February 9, 1993
LD-93-016

SUBJECT: Revisions to CESSAR-DC Chapter 15 Safety Analyses Results

REVISIONS TO CESSAR-DC CHAPTER 15

SYSTEM 80+ DESIGN AT 3914 MWt

FIGURE 15.5.2-1

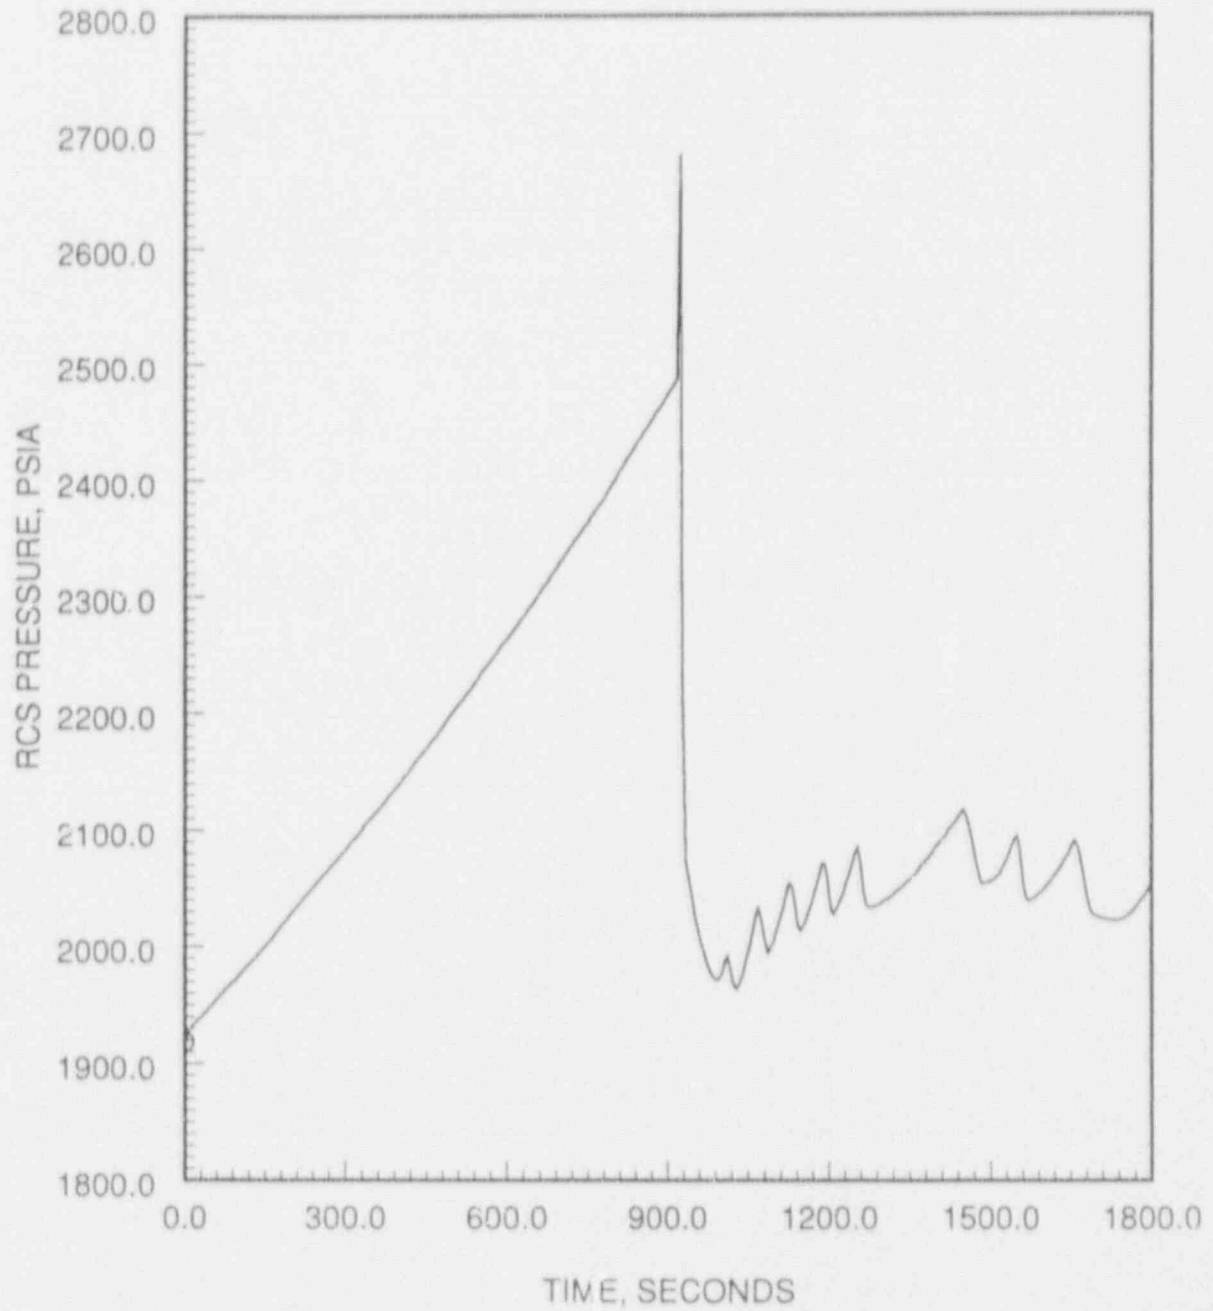
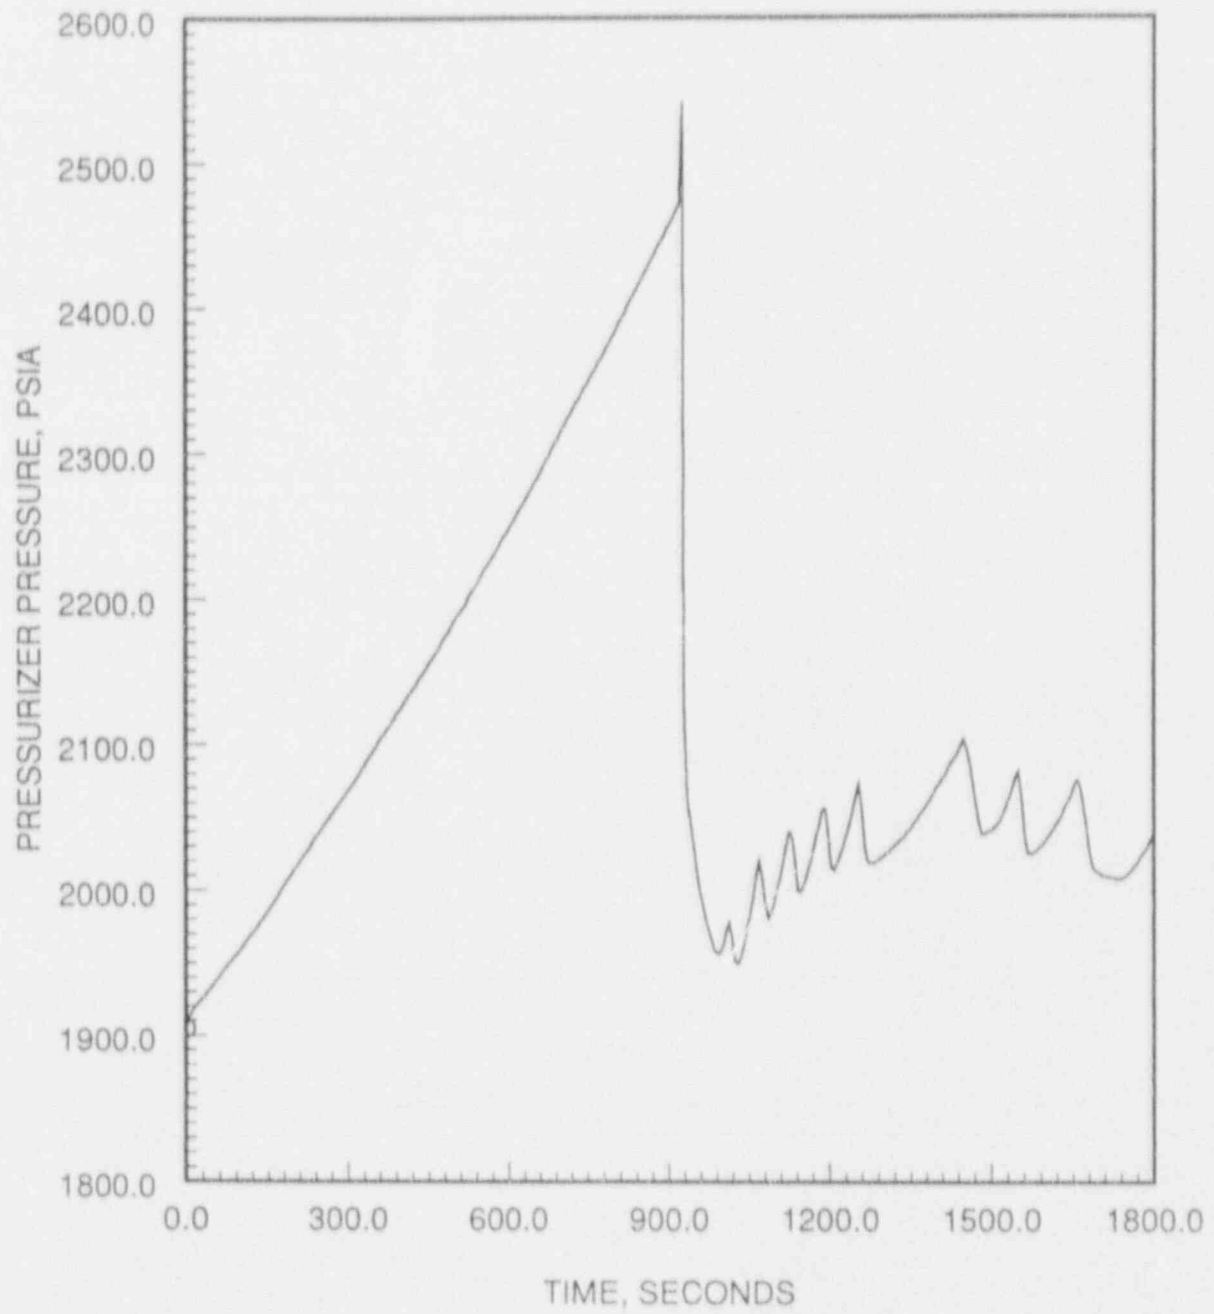
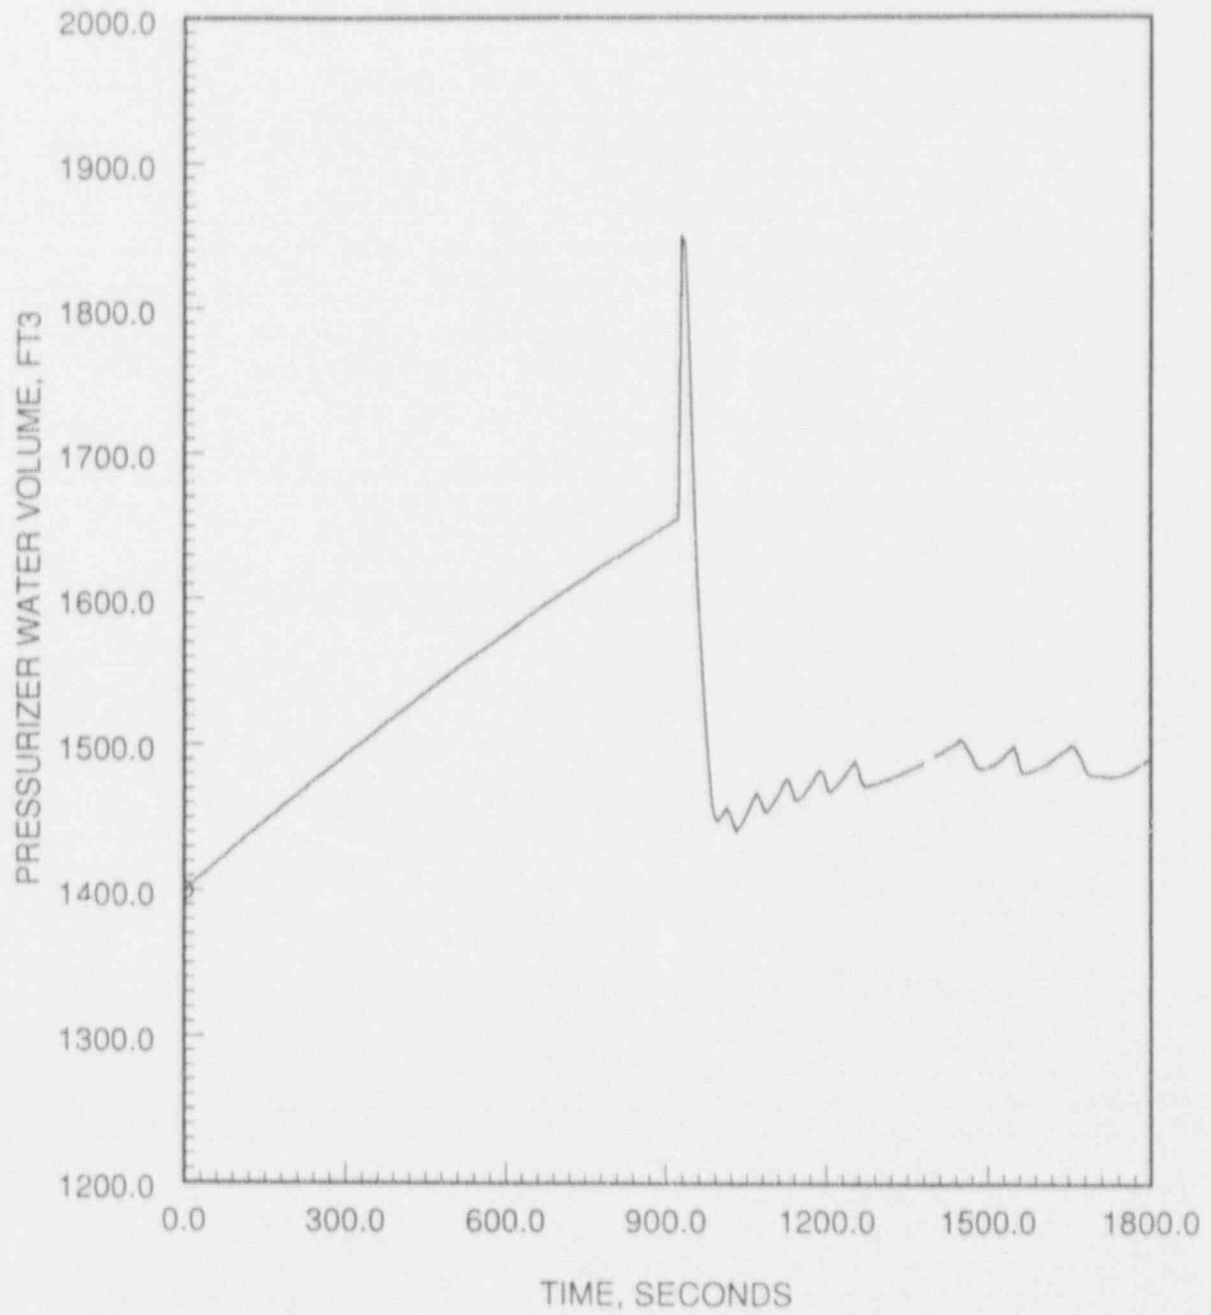
The event was analyzed assuming a failure in the pressurizer pressure and level control systems such that the pressurizer heaters failed to turn off and the charging flow was maximized and the letdown flow minimized. This resulted in the continuous filling of the pressurizer. The maximum RCS pressure was determined to be 2680 psia. The maximum steam generator pressure was determined to be 1267 psia. These values are less than 110% of the design pressures for the primary and secondary systems, respectively. The minimum DNBR was determined to remain above the SAFDL; thus, no fuel failures need be assumed. Table 15.5.2-1 presents the sequence of events and Table 15.5.2-2 lists the assumptions and initial conditions used for this analysis. Figures 15.5.2-1 through 15.5.2-3 present the dynamic response of the system to this event.
